RESPONSE TO IDEM RWP RESPONSE TO COMMENTS & ADDENDUM I REVIEW

**MICHIGAN PLAZA
3801-3823 WEST MICHIGAN STREET
INDIANAPOLIS, INDIANA**

IDEM INCIDENT NUMBER: 0000198

JANUARY 16, 2009

**UPGRADIENT MONITORING WELL LOCATIONS
(NOV-DEC 2008)**

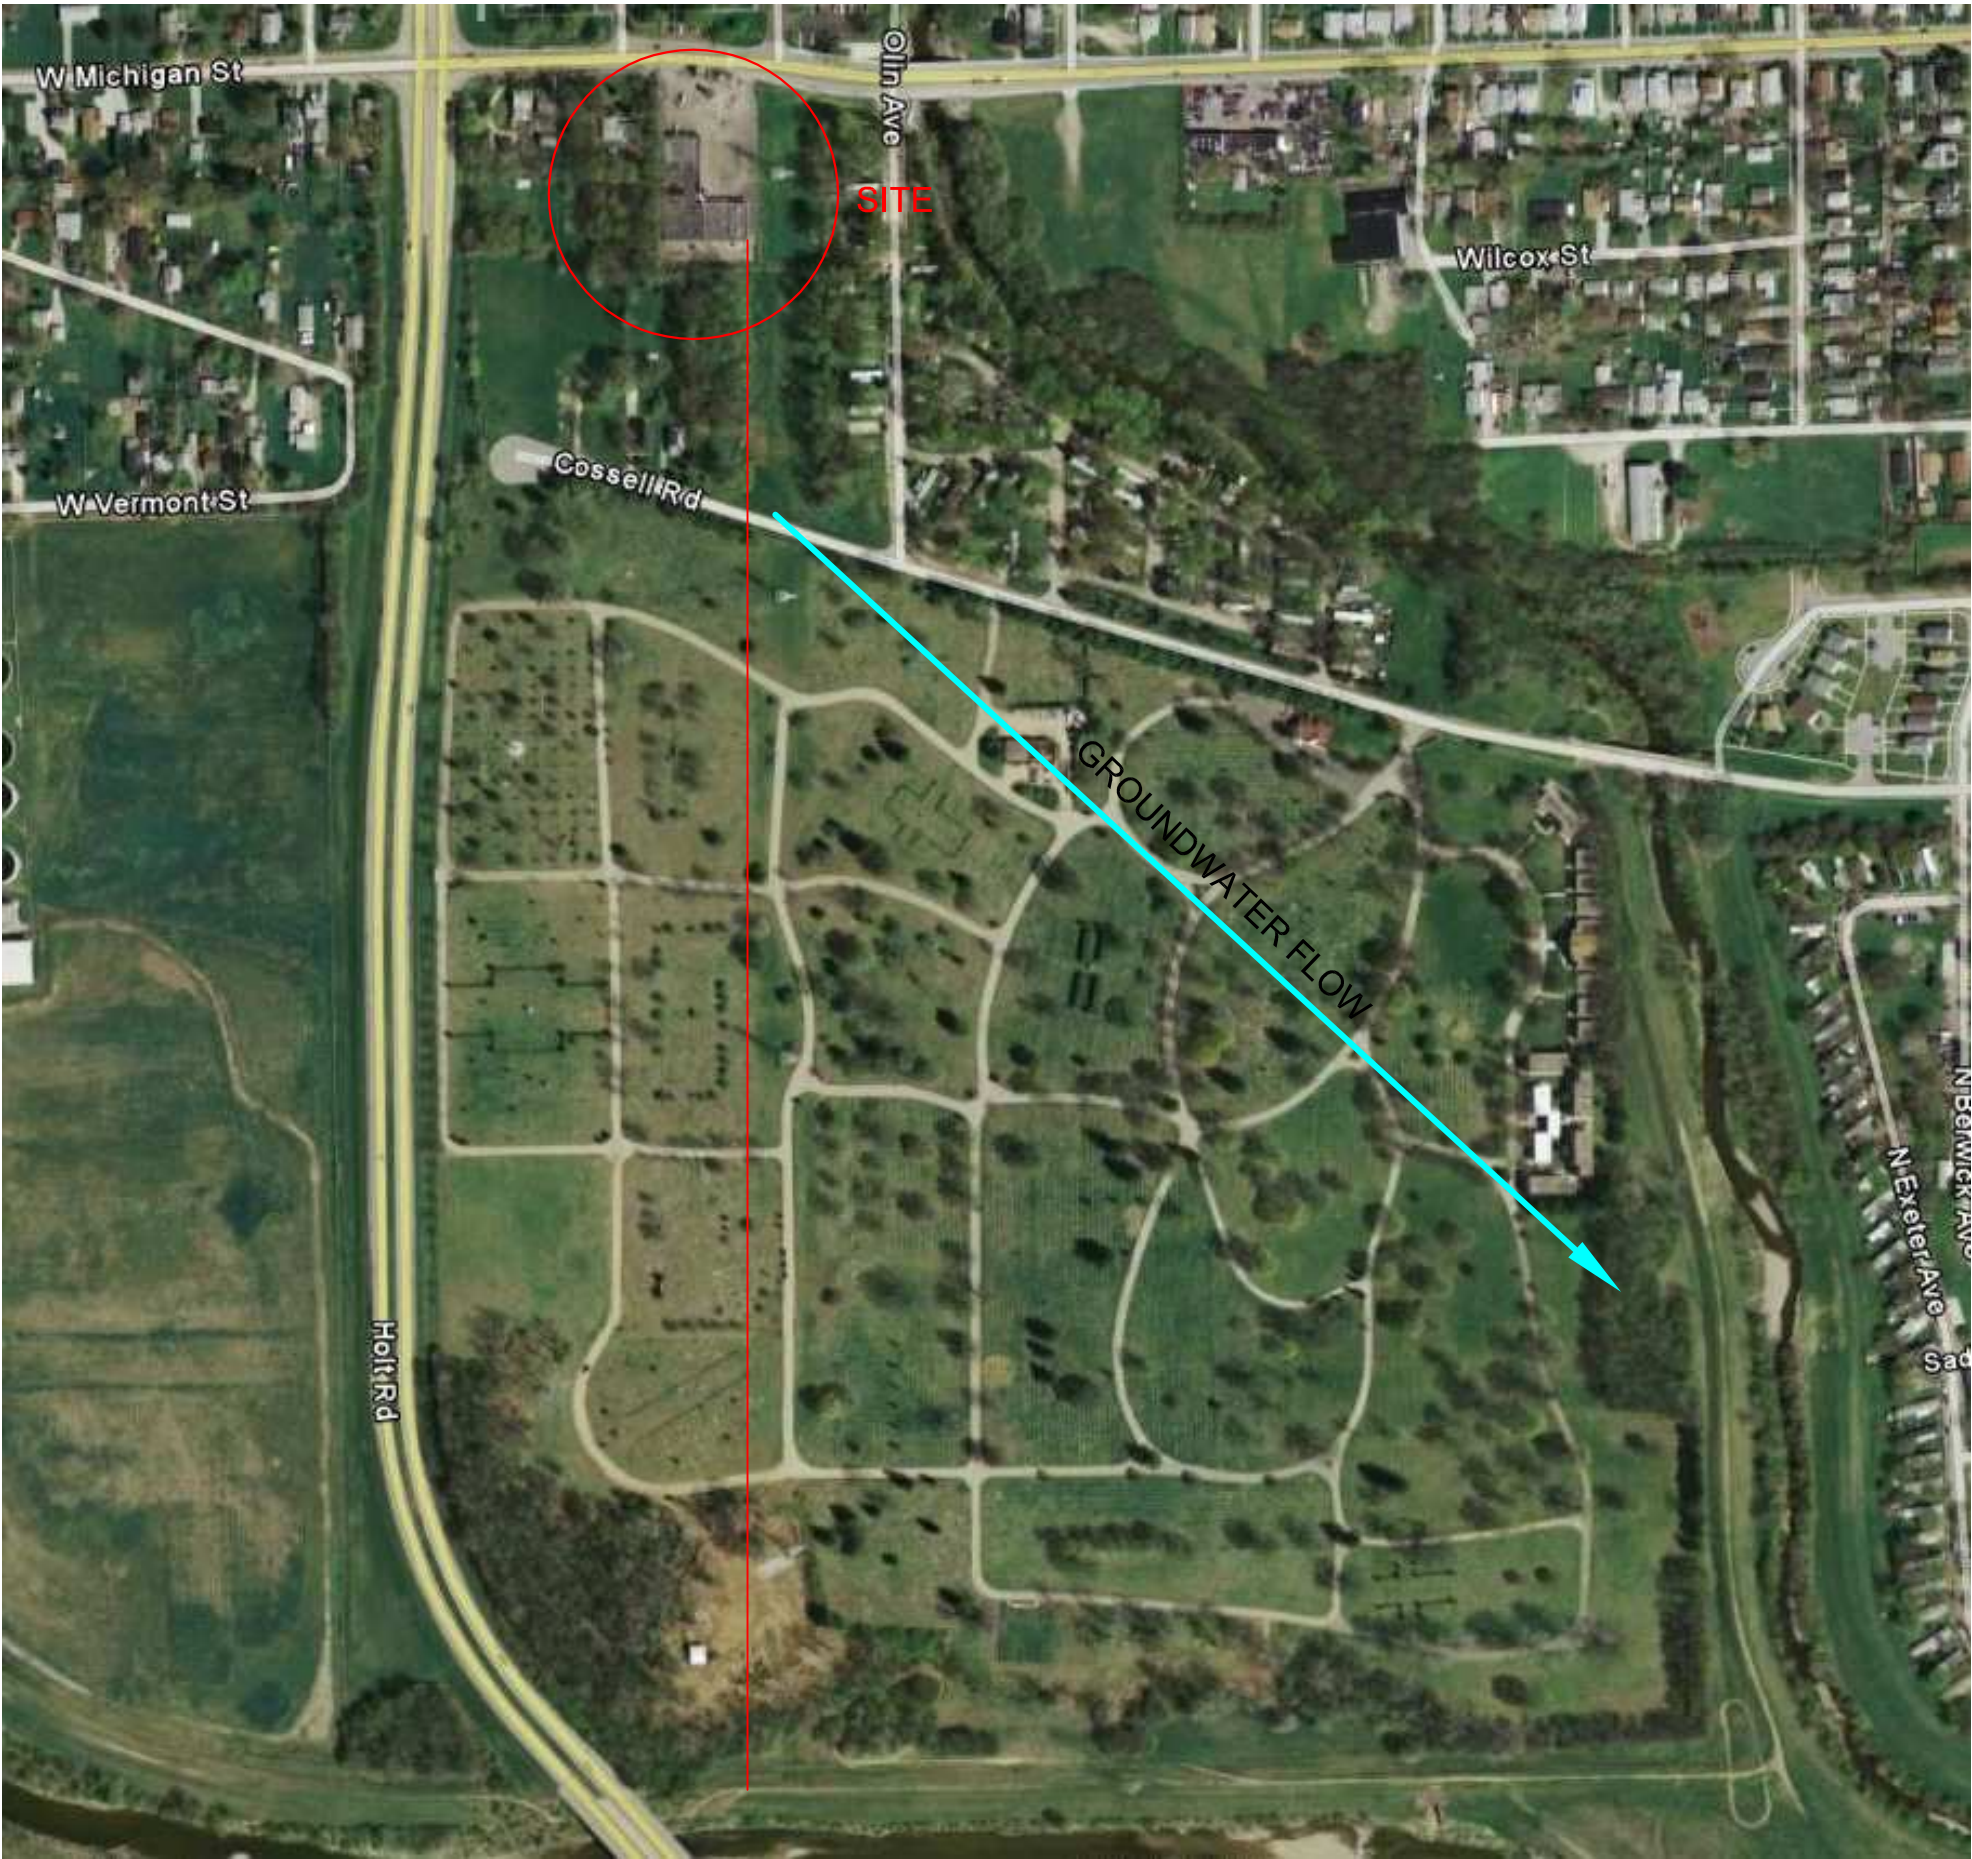
IDEM Comment No. 9. Response 8: The proposal to install two up-gradient deep wells rather than the three initially suggested by IDEM is generally acceptable. However, both wells are planned to be at least 100 feet up-gradient of the known sources of shallow contamination. Deep wells should be within 20 feet of the known source areas.

MUNDELL Response: Monitoring well MMW-11S is in the range of 20 to 30 feet from the plume (*Source Area B*, see attached **Figure 1**). The clay till isopleth map (*Refer to Fig 44 from the RWP*), indicates the hard pan (ranging from 32 to 37 feet in the area) represents the base of the aquifer and limited the depth of installation of MMW-11S. Hence, MMW-11S (screened from 23 to 33 feet to top of till) is essentially a deep well and is renamed MMW-11D.

After multiple data sets, we believe that the plume resulting from the sewer release (*Source Area C*) actually extends slightly north of what was initially thought (maybe to the northern edge of Building 1). The upgradient deeper wells are, therefore, slightly further away from the *Source Areas B and C* as a part of the effort to discern what is coming into the area from the upgradient Genuine plume.
